# Technical Service Bulletin

<b>Topic</b>	DTC P04F000 EVAP system high pressure purge line performance DTC logged
<b>Market area</b>	China 723 Volkswagen (Anhui) Automotive CO (6723),China 796 VW Import Comp. Ltd (Vico), Beijing (6796),Korea, (South) E08 Bentley South Korea (6E08),United States E05 Bentley USA and rest America (6E05)
<b>Brand</b>	Bentley
<b>Transaction No.</b>	2058573/5
<b>Level</b>	EH
<b>Status</b>	Released for publishing
<b>Release date</b>	Feb 21, 2025

Figure 2

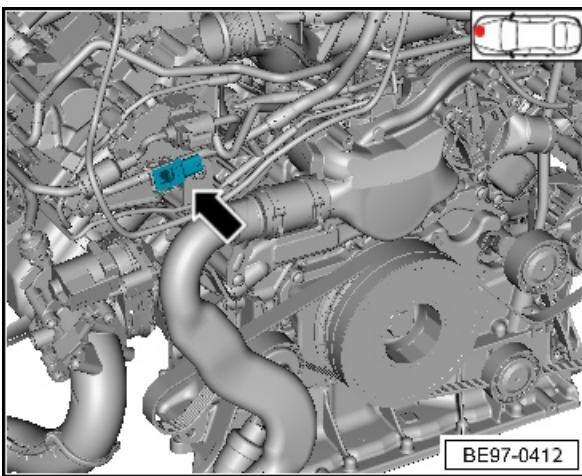
The DTC is related to mismatched terminal locations of the Pressure sensor for the activated charcoal filter system – G804 (Figure 2)

Figure 3

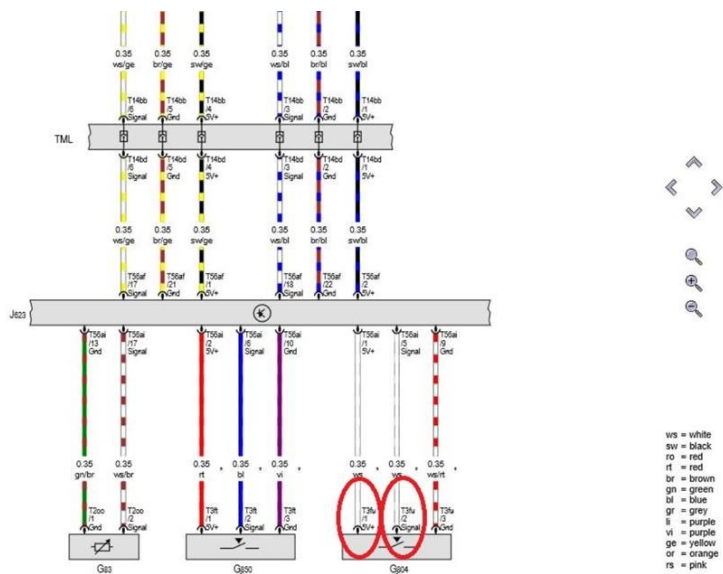
1) Refer to Wiring diagram 106/18 within Elsa pro (Figure 3)

2) Should the terminal locations NOT be as shown in Figure 3, the terminals should be reallocated within plug as per the wiring diagram

- Refer to Repair manual Rep.Gr 20 - Tank ventilation pressure sensors - To remove and fit to gain access to the sensor connection
- Reallocate the sensor terminals as per Elsa pro wiring diagram instruction
